# DEVELOPMENT REVIEW COMMITTEE (DRC) COMMENT REPORT

**PROJECT NAME:** Dalmar Hotel Signage

CASE NUMBER: R18050

REQUEST: Site Plan Level II Review: Signage in Downtown

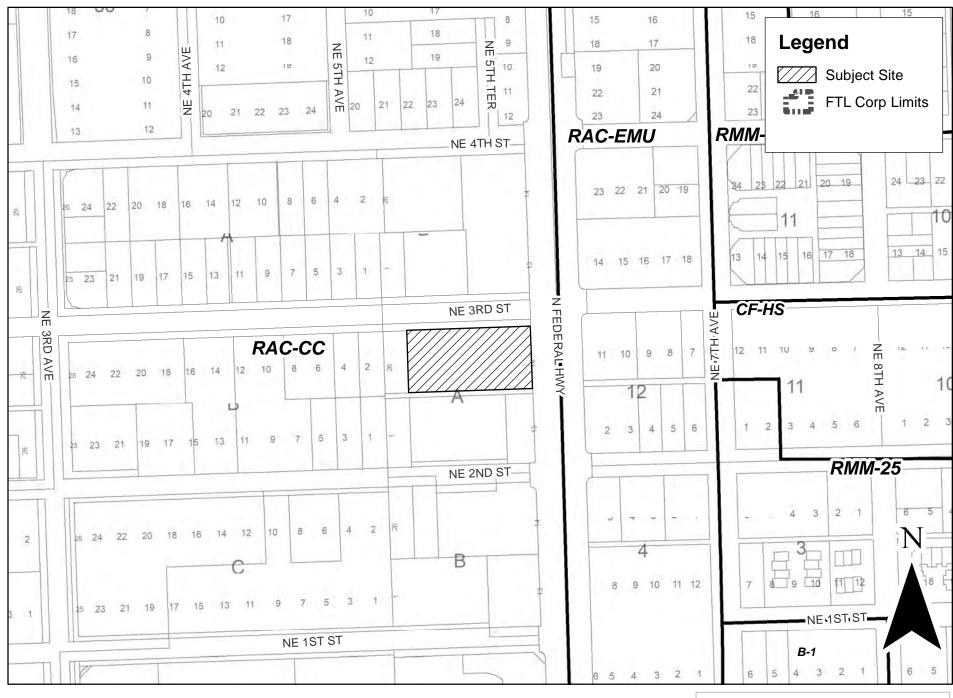
3. Staff recommends the sign be designed similar to the building façade sign facing NE 3<sup>rd</sup> Street as depicted on the building elevation in the approved site plan package. That sign contains a square box around the lettering. By incorporating a box around the proposed sign, there will be consistency in project signage, the overall aesthetics of the sign will improve, and will offset the architectural changes made to the tower top. The sign can be horizontal with the rectilinear boundary. For guick reference, the sign depicted in the approved plans is provided below.
